**OBJECTION TO THE ADDITIONAL DOCUMENTS SUBMITTED IN JANUARY 2021 re:
PLANNING APPLICATION TO REDEVELOP THE HOMEBASE SITE, SYON LANE, TW7 5QE
Ref: 00505/H/P19, P/2020/3099**

Objection submitted by the Osterley & Wyke Green Residents' Association (OWGRA), February 2021
(to be read in conjunction with previous objections submitted by OWGRA in November 2020)

Figure 3. Access Storage building at Gillette Corner (view from the A4 west)

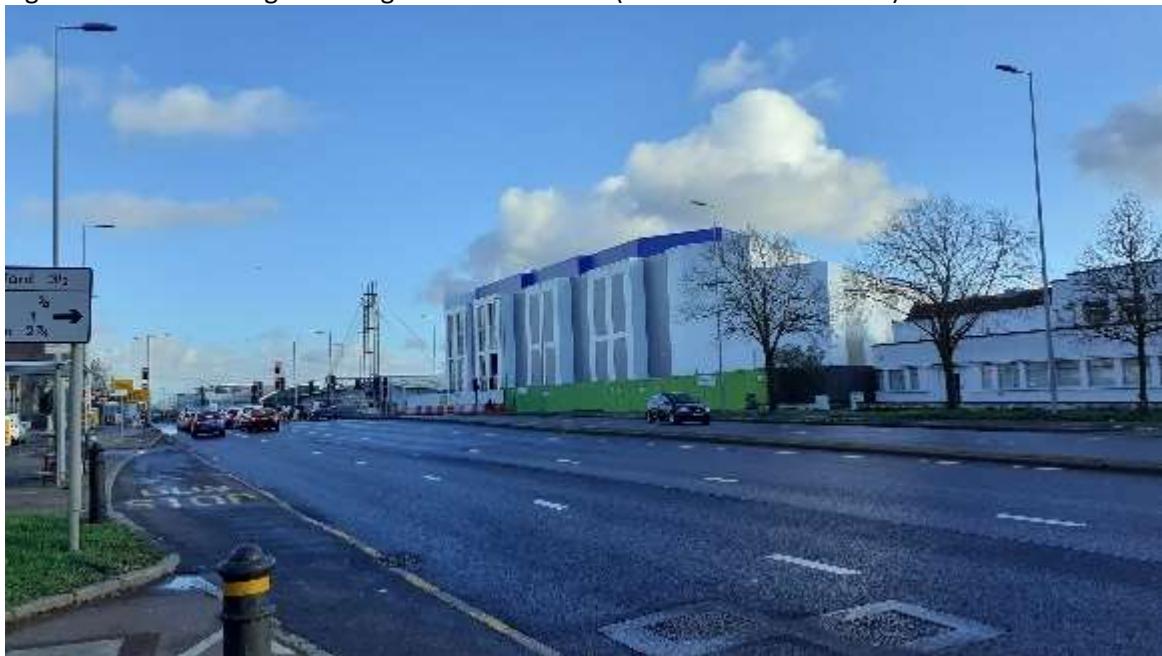
The height of the Homebase tower is 33m, roughly equivalent to 11 storeys. If the proposed development goes ahead, there would be a 17-storey tower block just to the left of where the Homebase tower is now. This is completely out of place in this area of 2-3 storey housing with a maximum height of 6 storeys of the new *Access Storage* building.
